Re: Railway (Metrolink - Estuary to Charlemont via Dublin Airport) Order [2022]
Metrolink. Estuary through Swords, Dublin Airport, Ballymun, Glasnevin and City Centre to
Charlemont, Co. Dublin

**Re: Railway (Metrolink–Estuary to Charlemont via Dublin Airport) Order 2022 –
Submissions by the Commissioners of Public Works in Ireland**

This submission is made in response to the statutory review of the Draft Railway Order. Accordingly, this submission has been prepared in the context of “Draft Railway Order 2022; MetroLink - Estuary to Charlemont via Dublin Airport” which seeks to deliver the construction of a fully segregated and automated railway and metro mostly underground c. 18.8km in length with 16 stations running from north of Swords at Estuary through Swords, Dublin Airport, Ballymun, Glasnevin, and the City Centre to Charlemont. The Draft Order is currently on public display. We would respectfully request that An Bord Pleanála consider the content within this submission. DOWNEY would like to thank the Board for the opportunity to make this submission, on behalf of the Commissioners of Public Works in Ireland (hereinafter the Office of Public Works (OPW), a prescribed body f

Figure 27. Settlement Contours (Extract from ML1-JAI-EIA-ROUT_XX-DR-Y-21147)

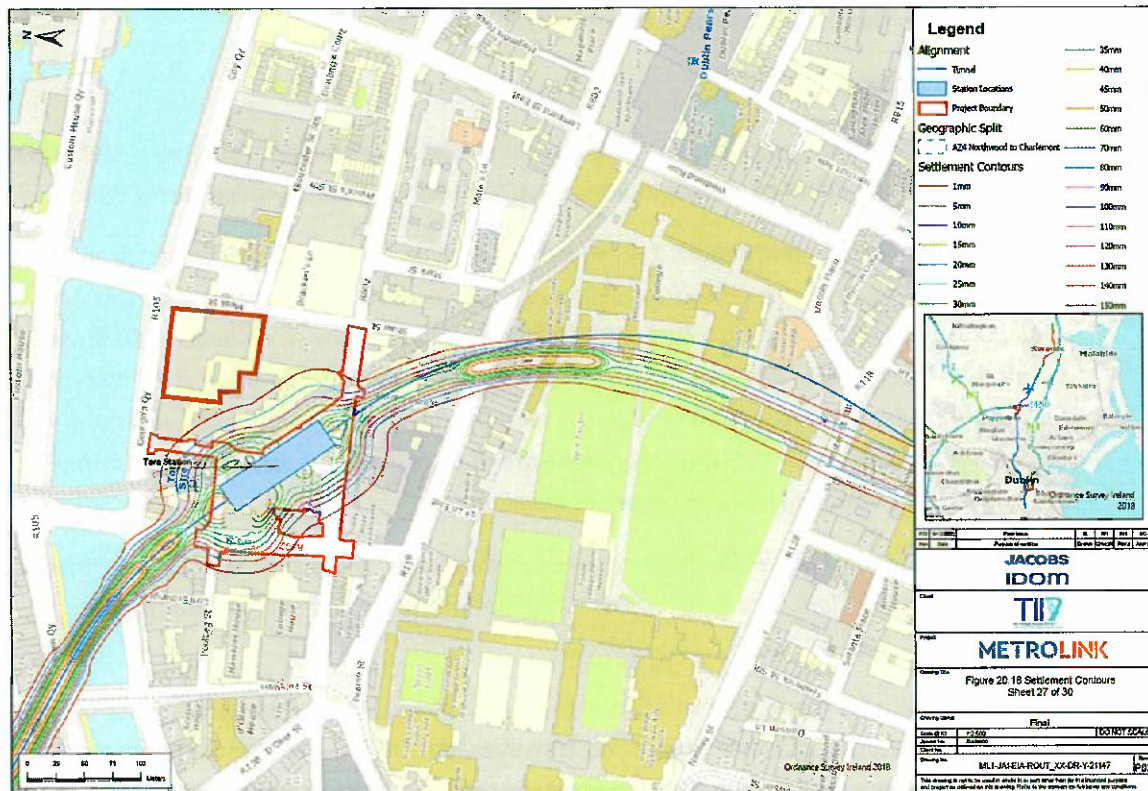
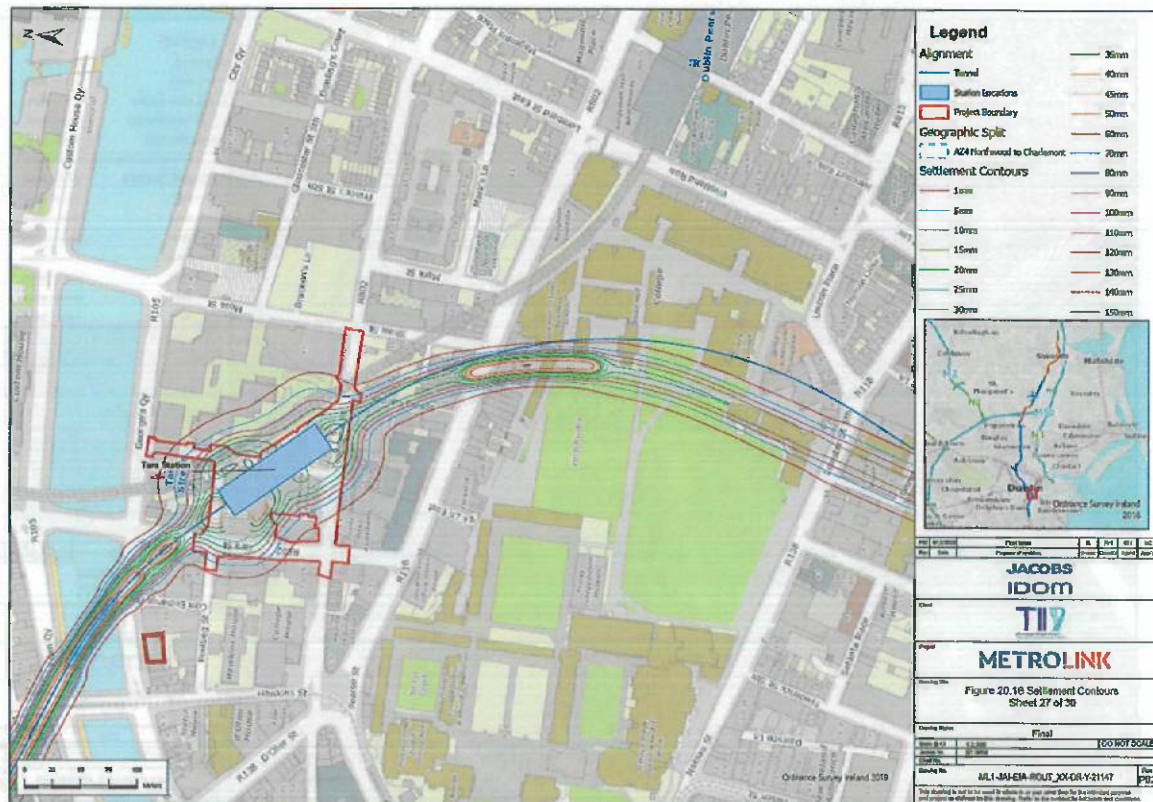
Stage 1: Defines extent of ground movement using Moderately Conservative parameters.

Figure 29. Settlement Contours (Extract from ML1-JAI-EIA-ROUT_XX-DR-Y-21149)

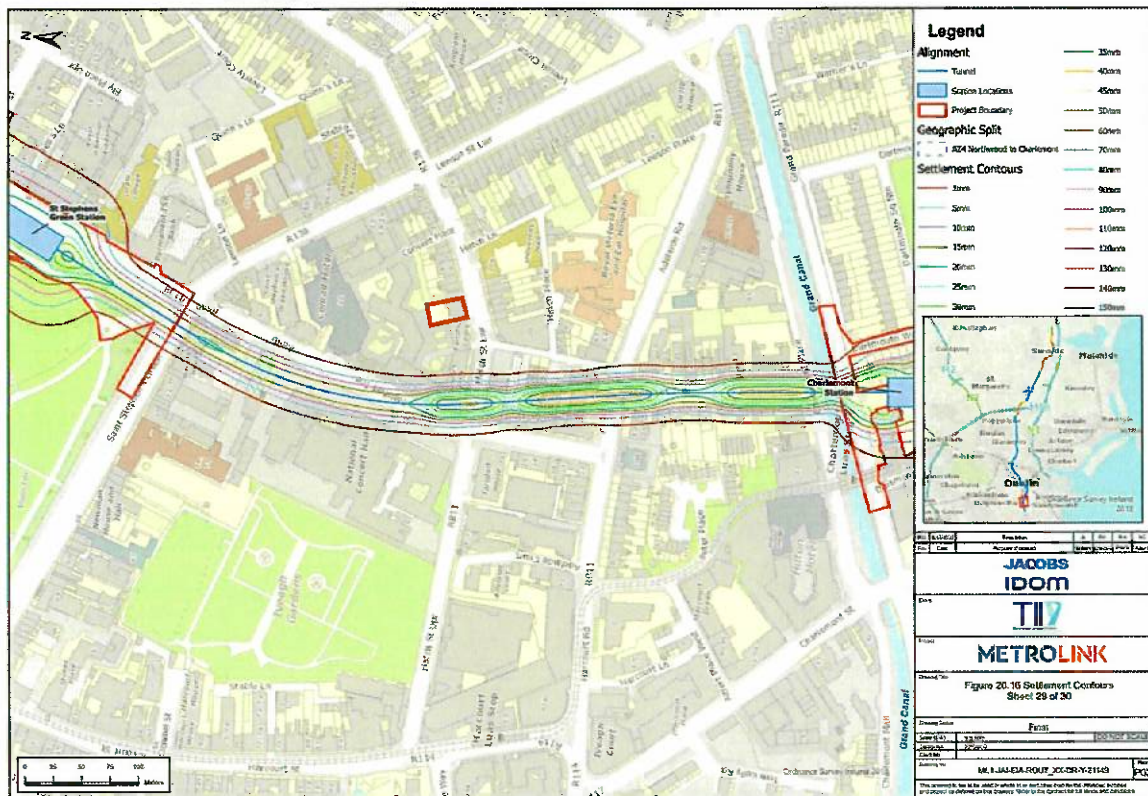
Stage 3: The OPW expects that a Stage 3 assessment will be carried out for 13-15 Hatch St by the Contractor appointed to construct this section of the MetroLink. The OPW expects to be consulted on the detail, scope of this assessment and programme for these assessments. It would be helpful if TII were to develop a Design Standard to ensure that all Stage 3 analyses of the OPW properties are carried out equally.

Stage 4 (Construction Stage): This stage is where any mitigation is implemented, and the monitoring of the stakeholder's infrastructure is carried out. Also, the pre-construction defect surveys are carried out prior to any excavation. The OPW requires to review the detailed proposals for mitigation and monitoring. Monitoring proposals submitted to the OPW for review should include deep level monitoring and ground water level monitoring in addition to the building and surface monitoring typically implemented. The deep level monitoring will provide valuable data relating to the rock behaviour and has been usefully employed on HS2.

Figure 30. Settlement Contours (Extract from ML1-JAI-EIA-ROUT_XX-DR-Y-21148)

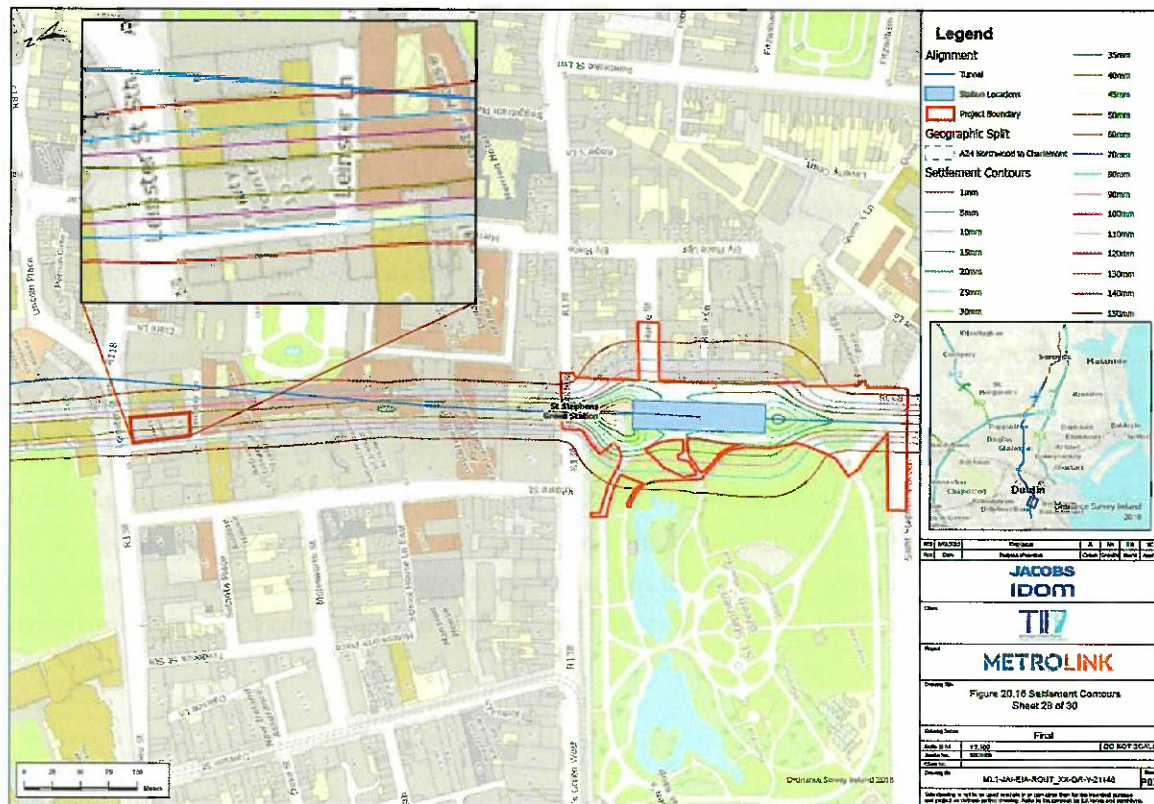
Stage 3: The EIAR states that a Stage 3 assessment will be carried out for Trinity Point by the Contractor appointed to construct this section of the MetroLink. The OPW expects to be consulted on the detail, scope of this assessment and programme for these assessments. It would be helpful if TII were to develop a Design Standard to ensure that all Stage 3 analyses of the OPW properties are carried out equally.

Stage 4 (Construction Stage): This stage is where any mitigation is implemented, and the monitoring of the stakeholders' infrastructure is carried out. Also, the pre-construction defect surveys are carried out prior to any excavation. The OPW requires to review the detailed proposals for mitigation and monitoring. Monitoring proposals submitted to the OPW for review should include deep level monitoring and ground water level monitoring in addition to the building and surface monitoring typically implemented. The deep level monitoring will provide valuable data relating to the rock behaviour and has been usefully employed on HS2.

Figure 31. Settlement Contours (Extract from ML1-JAI-EIA-ROUT_XX-DR-Y-21149)

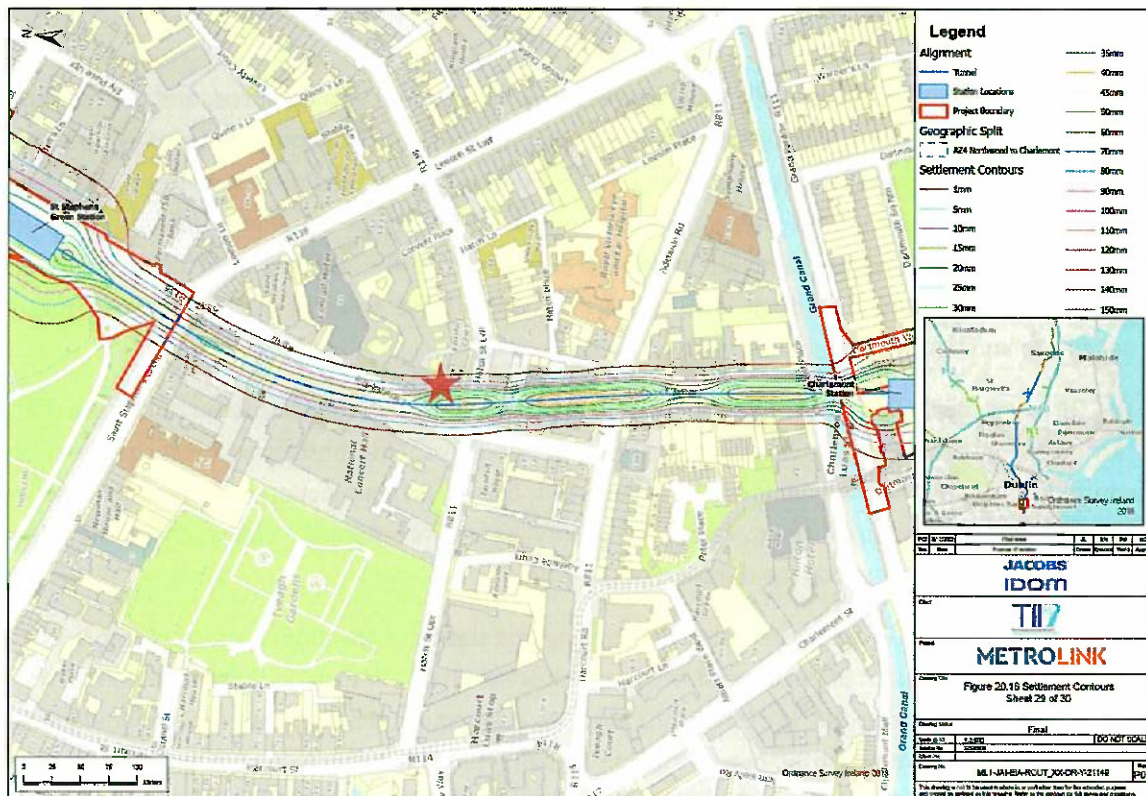
Stage 1: Defines extent of ground movement using Moderately Conservative parameters. The parameters considered by MetroLink are:

Stage 5 (Close out): Once the excavation (tunnelling and station excavation) has been completed then the Contractor will want to decommission his monitoring. The OPW expects to be provided with close out reports for the monitoring of their property. As a minimum the close out report should include details of any mitigation carried out, a list of any repairs, time history graphs showing the movements monitored.

Figure 32. Settlement Contours (Extract from ML1-JAI-EIA-ROUT_XX-DR-Y-21146)

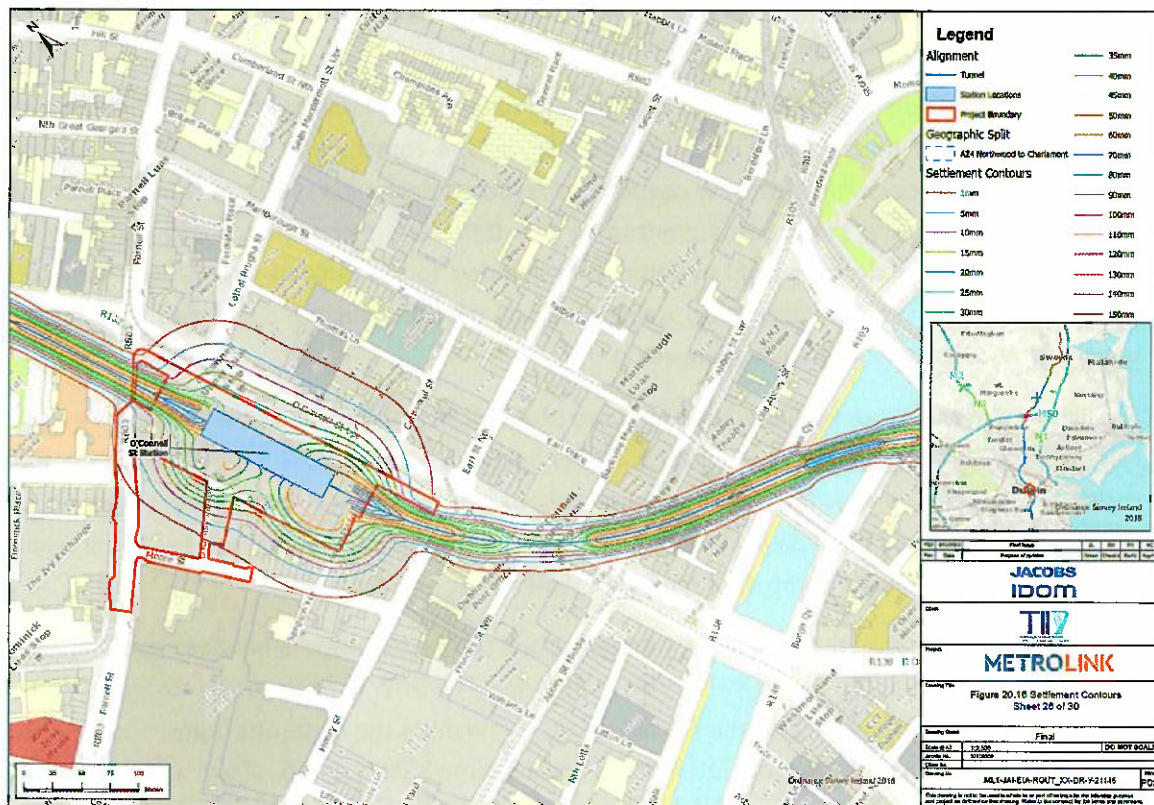
Stage 1 (Definition of Zone of Influence): Defines extent of ground movement using Moderately Conservative parameters. The parameters considered by MetroLink are:

Figure 33. Route Diversion During Construction Phase in Vicinity of the Property

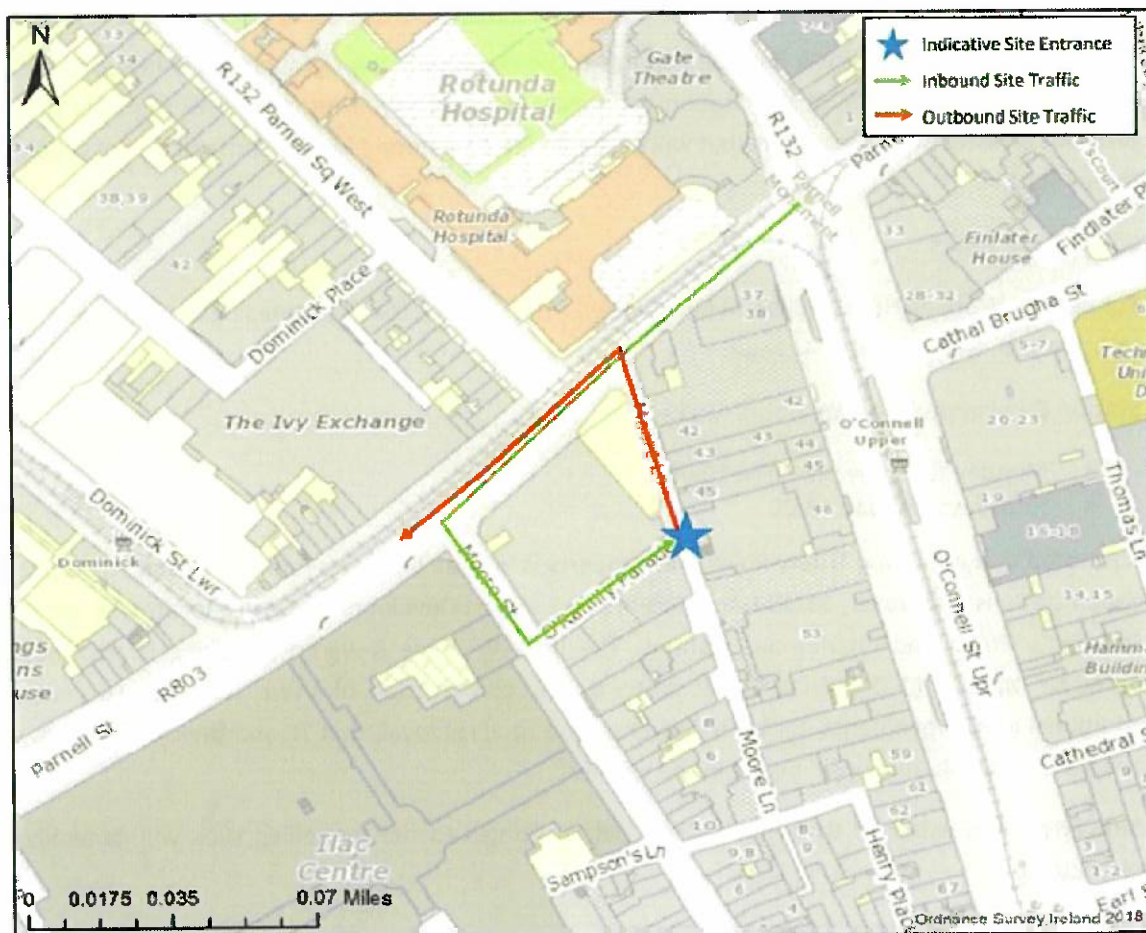
In relation the INTREO Office & Parkrite Parking and its proximity to the O'Connell Street Station, there will be significant traffic management required to construct this Station site, and that may impact personnel and clients attending the property and/or using car parking at the INTERO Office & Parkrite Parking. It is noted that the Traffic Management Plan envisages that all construction traffic from O'Connell Street Station construction will be routed west along Parnell Street. Accordingly, the OPW requests that TII carry out a study to consider the impact on the Parkrite car parking at Loftus Lane.
